S. S. Manuel L. Villaverde
Glasgow Report
No. 5941

Sketch showing Arrangement of Deck Beams & Iron deck & Deck Openings with reference to plan submitted showing arrangement of web frames and strong beams in Engine Room.

Plan of Main Deck

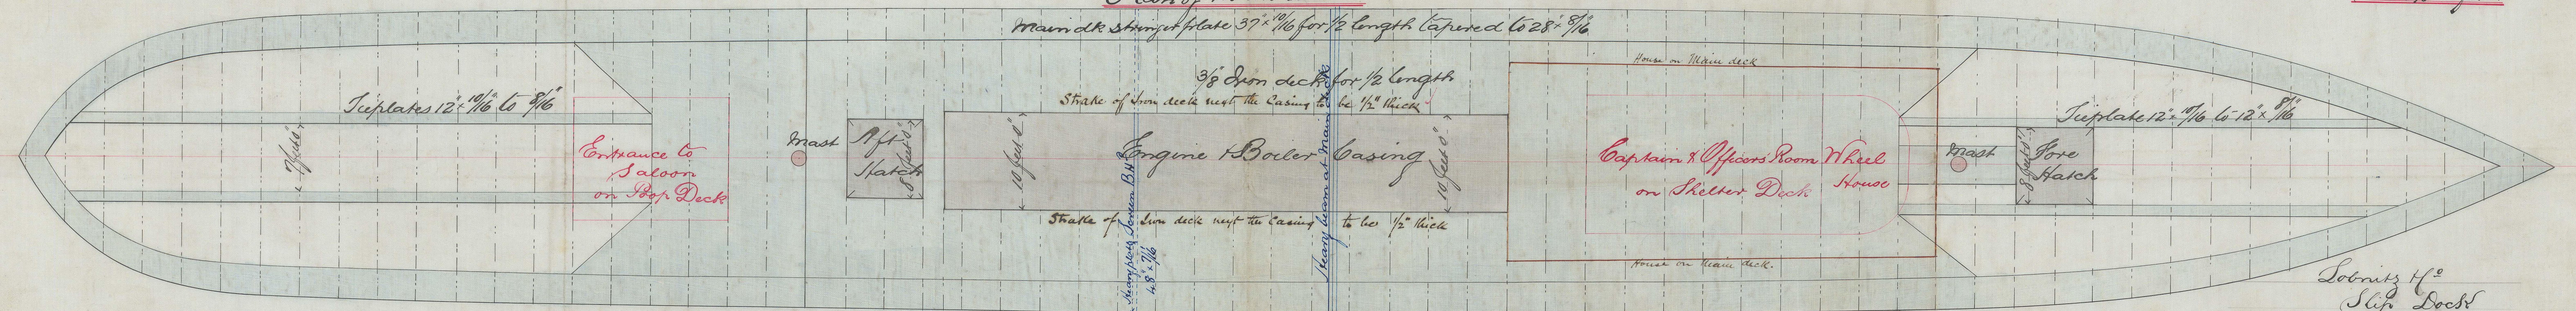
Proposed compensation for cargo port.

The shearstrake doubling to be extended aft to 5 feet beyond the port, an angle iron frame 5" x 4" x 3/8" to be fitted round the port, and a bull plate say 12 feet long of 10" x 3/8" to be fitted at lower edge of port.
